**Minutes of the North Carolina Building Code Council
September 11, 2018
Raleigh, NC**

**FIGURE AM109.1(1)
NO LATERAL BRACING**

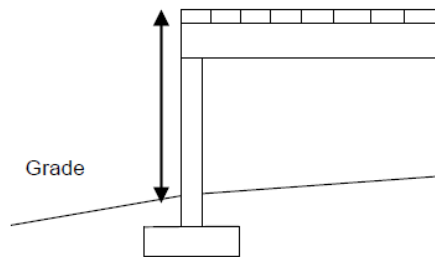
When the deck floor height is less than 4 feet (1219 mm) above finished grade as shown in Figure AM109.1(1) and the deck is attached to the structure in accordance with Section AM104, lateral bracing is not required. Lateral bracing is not required for freestanding decks with a deck floor height 30 inches (762 mm) or less above finished grade.

**FIGURE AM109.1(2)
KNEE BRACING**

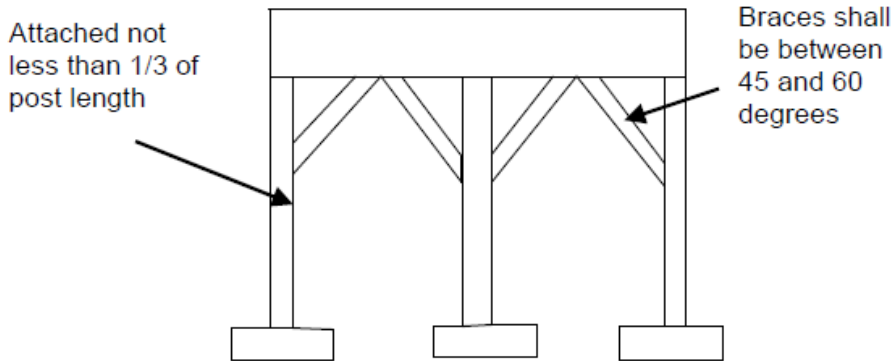
4x4 wood knee braces are permitted to be provided on each column in both directions for freestanding decks or parallel to the structure at the exterior column line for attached decks per Figure AM109.1(2). The knee braces shall attach to each post at a point not less than 1/3 of the post length from the top of the post, and the braces shall be angled between 45 degrees (0.79 rad) and 60 degrees (1.05 rad) from the horizontal. Knee braces shall be ~~bolted~~ fastened to the post and the girder/double band in accordance with one 5/8 inch (16 mm) hot dip galvanized bolt with nut and washer at both ends of the brace of the methods shown in Table AM109.1; as shown in Figure AM109.1(2).

**FIGURE R4603.6(b)
TOP MOUNTED GIRDER**

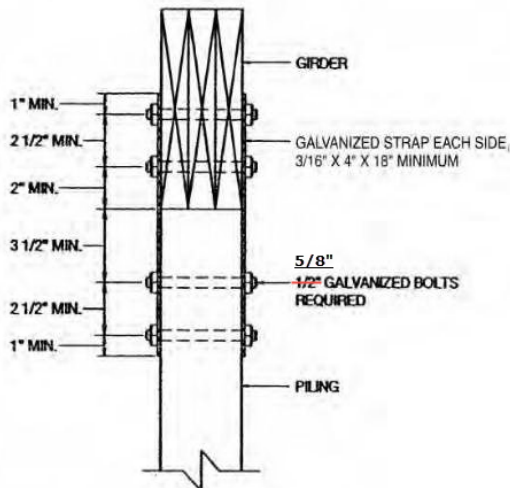
Beams and girders shall fully bear on pilings and butt joints shall occur over pilings. If sills Sills, beams or girders are shall be attached to the piling a minimum of two 5/8 inch (16 mm) galvanized steel bolts per beam member shall be through bolted using either bolts or screws at each piling connection in accordance with Table R4603.6 and Figure R4503.6 (a) R4603.6. When the piling is notched so that the cross-section is reduced below 50 percent or the girder is top bearing, sills, beams or girders shall be attached using 3/16 × 4 × 18-inch (5 × 102 × 467 mm) hot dip galvanized straps, one each side, bolted with two 5/8 inch (15.9 mm) galvanized through bolts fastened top and bottom with either bolts or screws in accordance with Table R4603.6 and Figure R4603.6(b) and Figure R4503.6(e) R4603.6(c). Where butt joints occur over the piling and screws are used, there shall be two straps on each side of the piling, having a minimum size of 3/16 by 2 by 18 inches (5 × 51 × 467 mm), with four self-drilling screws as described in each end.

Revise Figures as follows:

Figure 410.2 Exception Closet Storage Space Exception

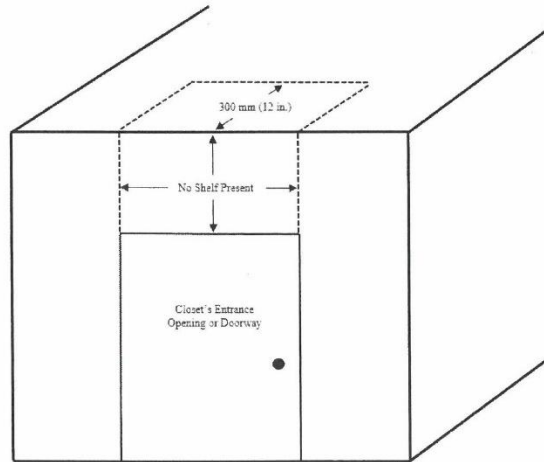
Where a shelf is not present in the area of wall above the closet's entrance opening or doorway extending from the top of such opening or doorway vertically to the ceiling, including the area of ceiling extending perpendicular from the area of wall directly above the closet's entrance opening or doorway to a horizontal distance of 300 mm (12 in.), shall not be defined as closet storage space. See Figure 410.2 Exception.

Note: A comma was added after "(12 in.)," in the Exception paragraph.
